NuBlend Commercial Blenders

**BB180**

3 Part Changes

Starting With **Unit Date Code 130308** (3/8/2013)

Top View 029794 or 033056 Motors

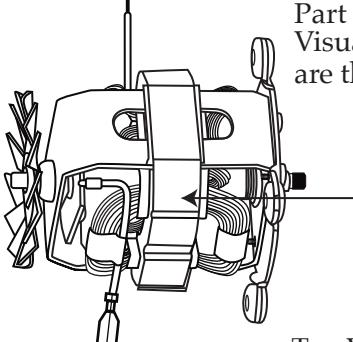
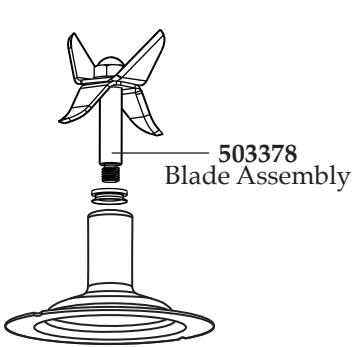
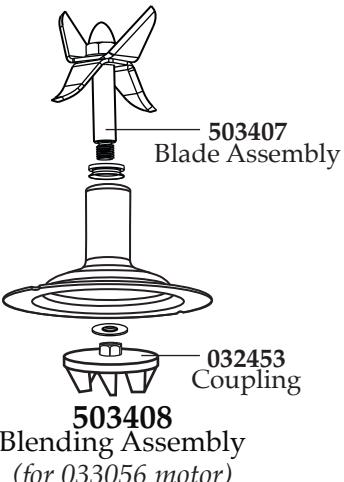
Part # is printed on each motor.  
Visually you may think motors  
are the same **but they are not.**

027097  
Coupling  
(for 029794 motor)

503377  
Blending Assembly  
(for 029794 motor)

503408  
Blending Assembly  
(for 033056 motor)

032453  
Coupling  
(for 033056 motor)
